## P1658 Digital to Analog Standard Meeting, May 19, 2008

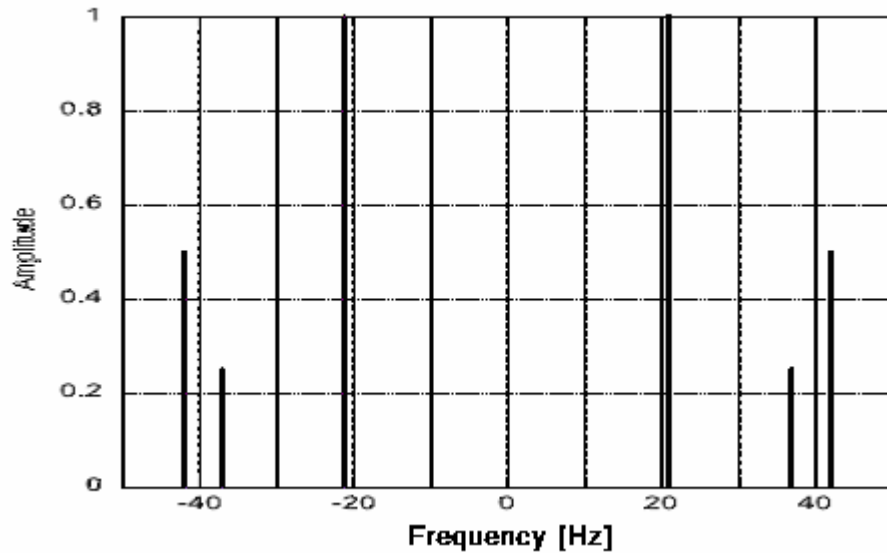
Figure 10 was modified to explicitly use the units Hz for the horizontal axis. See modified Figure 10 below;

Figure 17 –

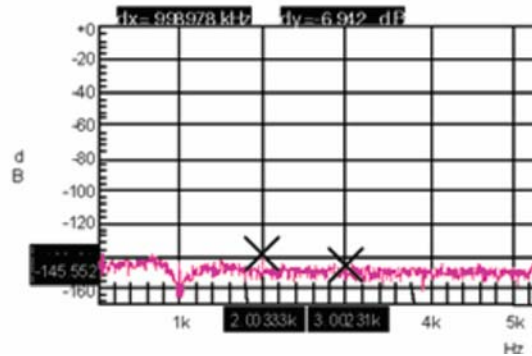
A new Figure 17 is required with more information concerning what is displayed. The current Figure 17 is shown below.

The repair of the section is assigned to Solomon Max
